Tropico Middle School Landscape, Drainage and Parking Lot Upgrade Project  
SOUTHERN KERN UNIFIED SCHOOL DISTRICT  
F&M Project No. 2940.0400  
Bid Clarification No. 2; Page 1 of 28

**BID CLARIFICATION NO. 2**

January 30, 2025

C3.03

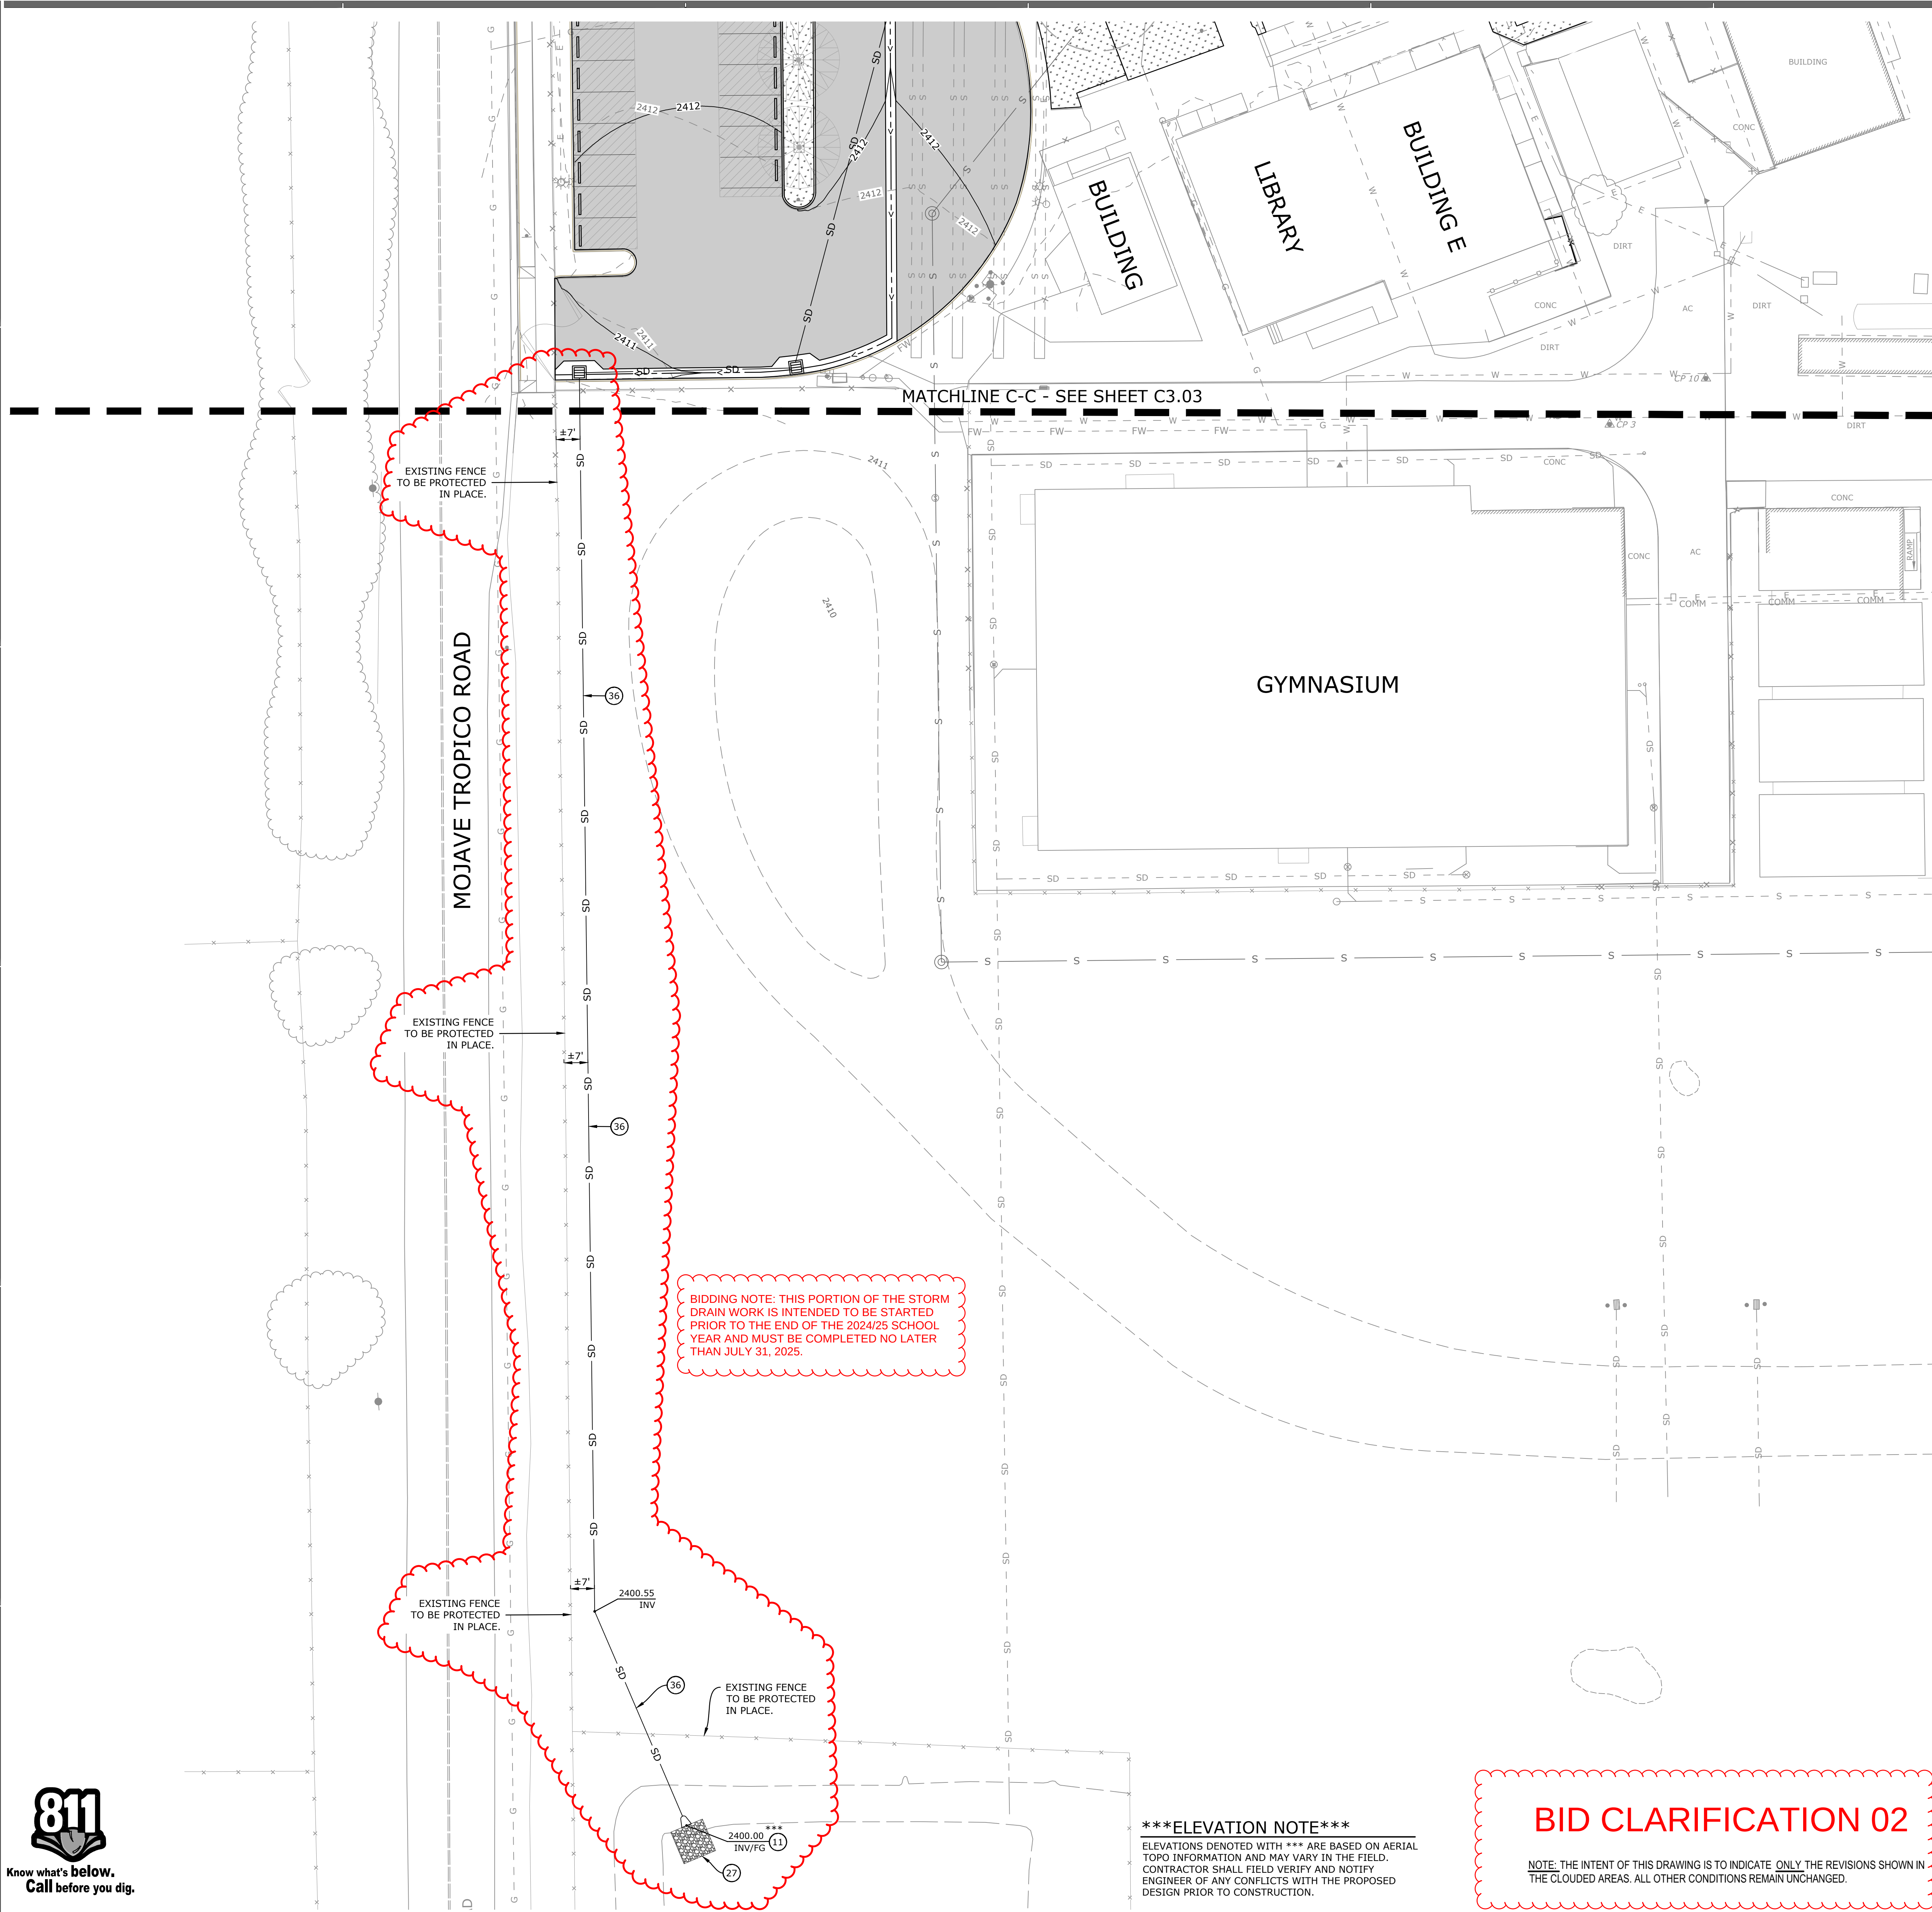
1. Sheet C3.03 - **Revise** sheet as shown in the “clouded” areas on sheet “C3.03 – Grading, Drainage and Paving Plan”, Bid Clarification No. 02 as attached hereto. (1 sheet).
2. Sheet C3.04 - **Revise** sheet as shown in the “clouded” areas on sheet “C3.04 – Grading, Drainage and Paving Plan”, Bid Clarification No. 02 as attached hereto. (1 sheet).

## BID CLARIFICATION 02

NOTE: THE INTENT OF THIS DRAWING IS TO INDICATE ONLY THE REVISIONS SHOWN IN THE CLOUDED AREAS. ALL OTHER CONDITIONS REMAIN UNCHANGED.

# SHEET BC02-01- TREE MAP

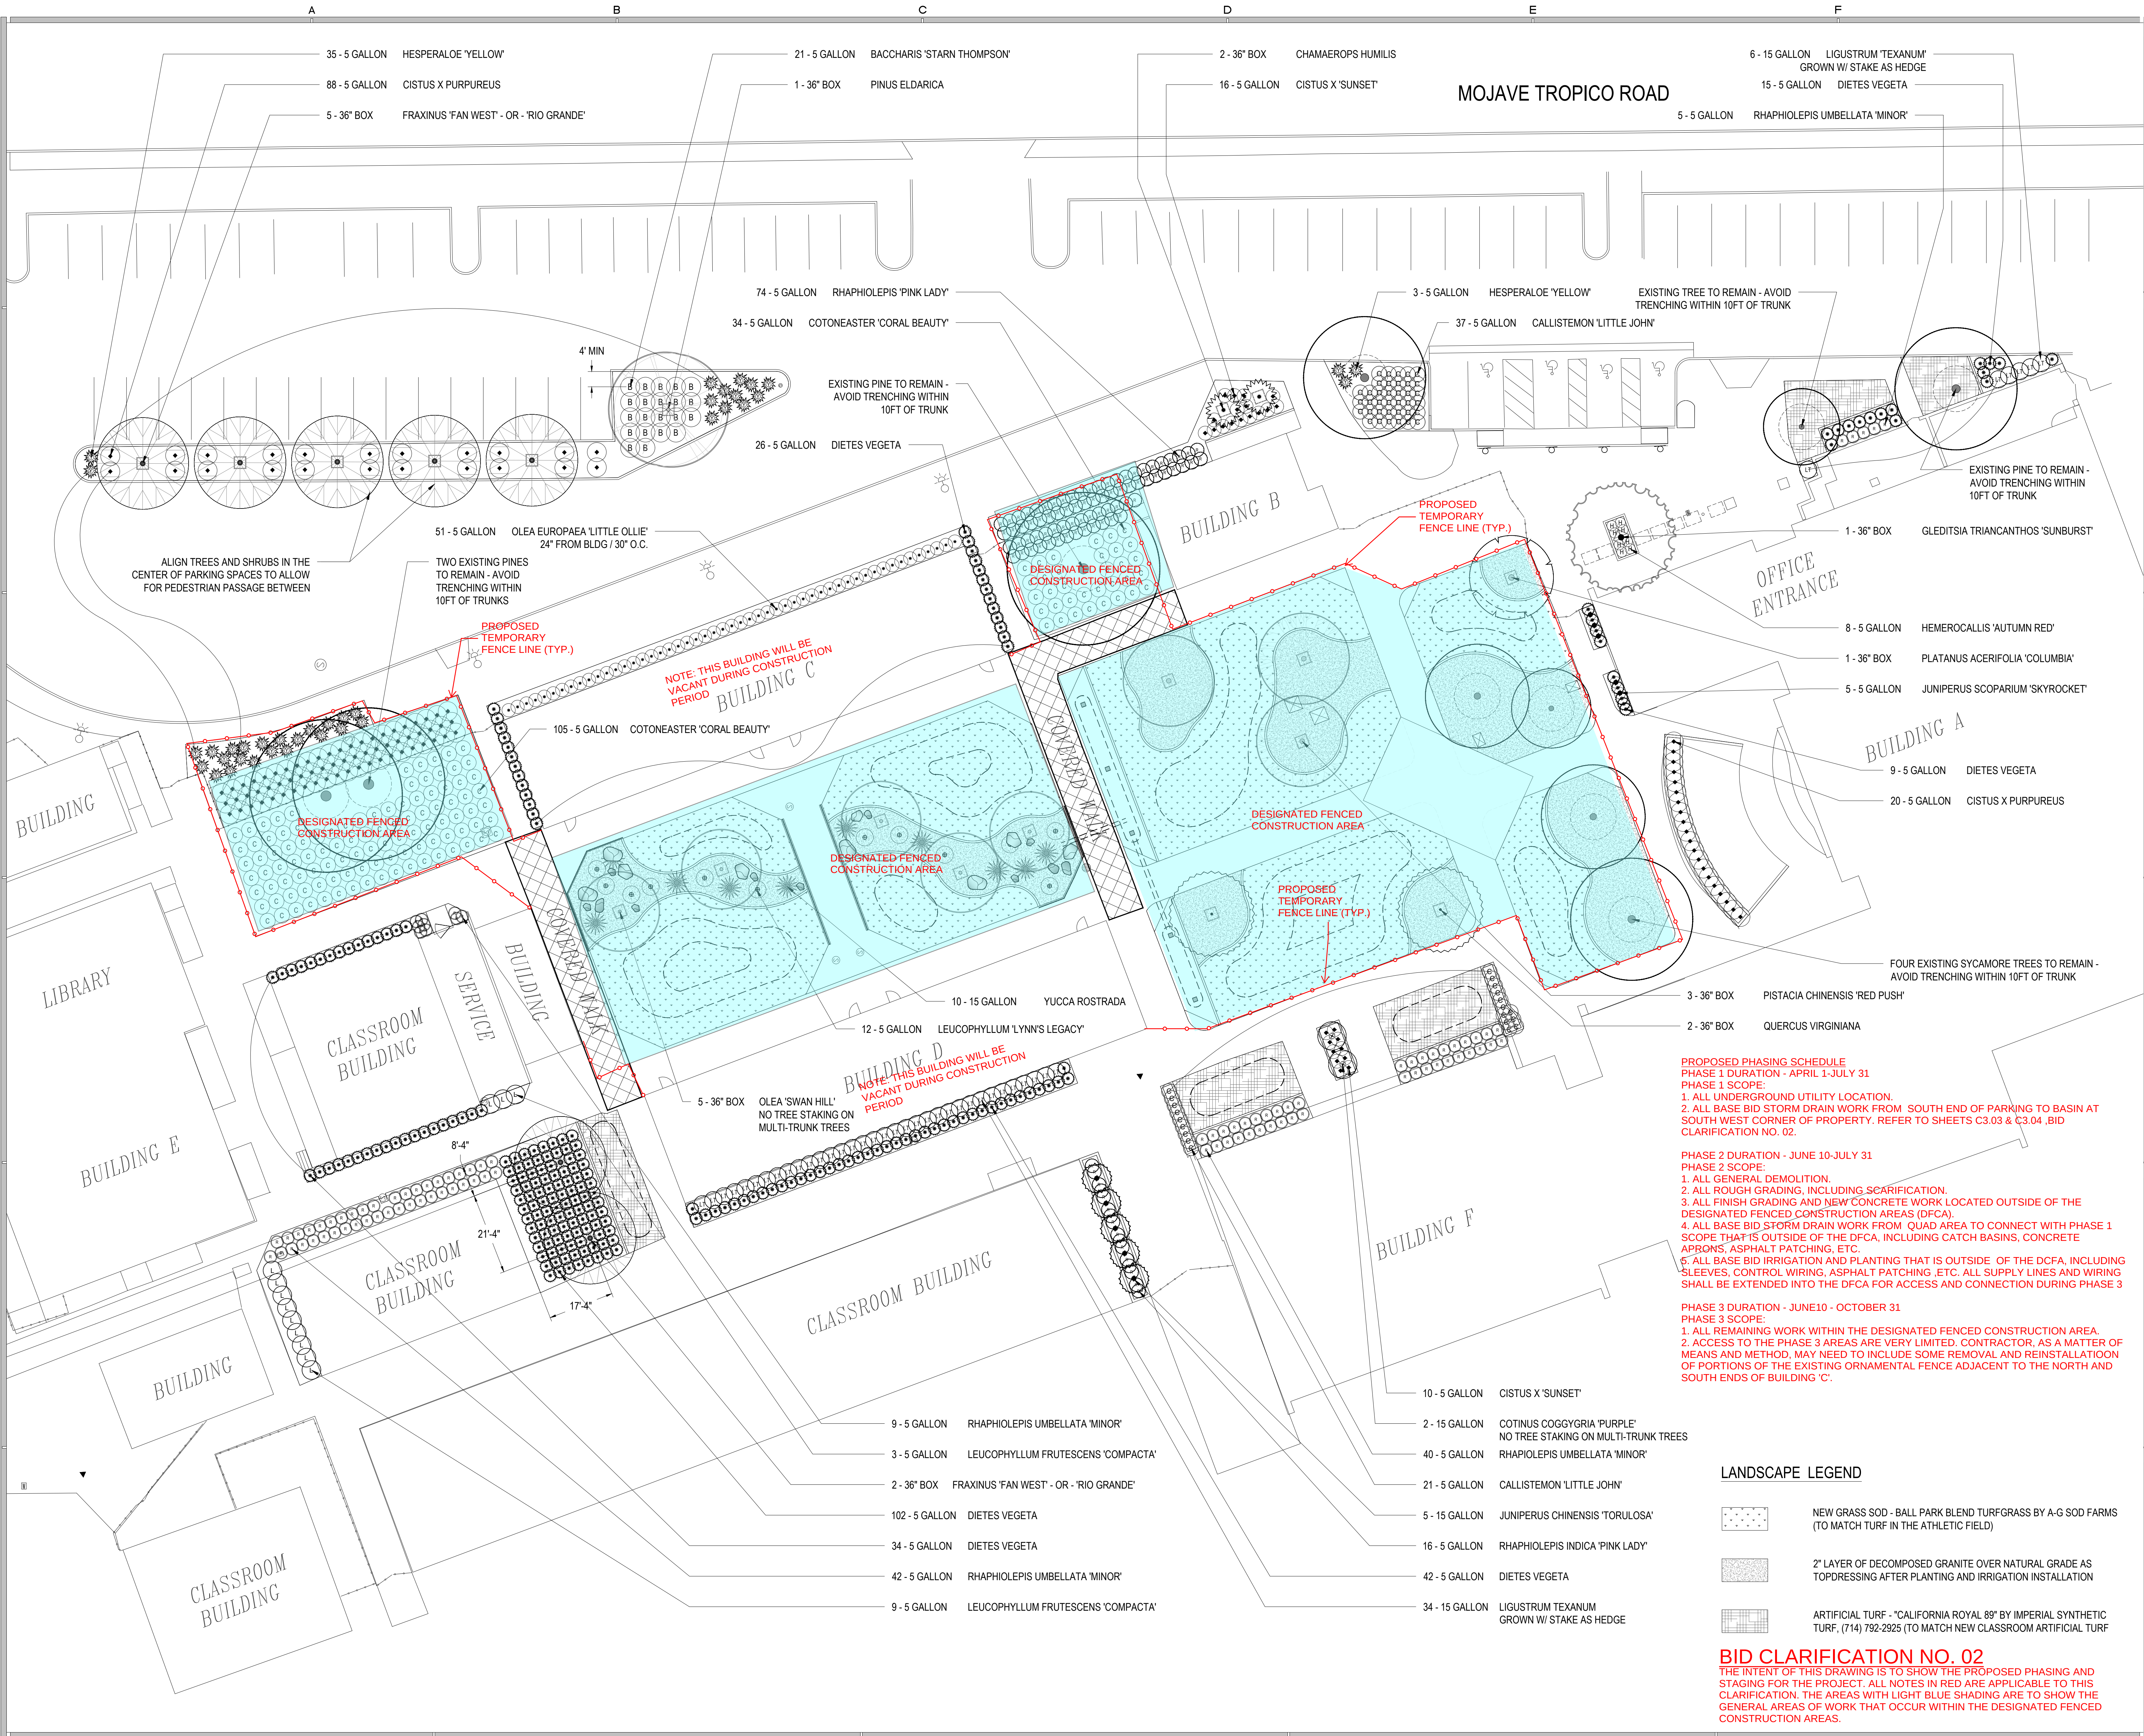
3. Sheet L1.03 - **Revise** sheet as shown in the "clouded" areas on sheet "L1.03 - Auguring Plan", Bid Clarification No. 02 as attached hereto. (1 sheet).
4. **Add** Sheet BC02-01, "Tree Map", Bid Clarification No. 02, as attached hereto. The contractor shall include the excavation and removal of all tree root balls as indicated and required for installation of new work.
5. **Add** Sheet BC02-02, "Proposed Phasing Plan", Bid Clarification No. 02, as attached hereto. (1 sheet) The contractor shall include all conditions for phasing and staging of the work as indicated on this document.

NOTE: THE INTENT OF THIS DOCUMENT IS TO SHOW LOCATIONS OF RECENTLY REMOVED TREES THAT THE CONTRACTOR SHALL BE RESPONSIBLE FOR EXCAVATING AND REMOVING THE REMAINING ROOT BALLS.

**NOTE: ALL TREE LOCATIONS INDICATED WITH A "RED SLASH MARK" ARE TREES THAT HAVE BEEN RECENTLY CUT DOWN AND HAD THE STUMPS GROUND. AS REQUIRED TO PERFORM THE NEW WORK, THE CONTRACTOR SHALL EXCAVATE AS REQUIRED TO REMOVE ALL ROOT BALLS, IN THERE ENTIRETY AND PROVIDE SUITABLE FILL MATERIALS AND COMPACTION TO FILL THE RESULTING VOIDS.**
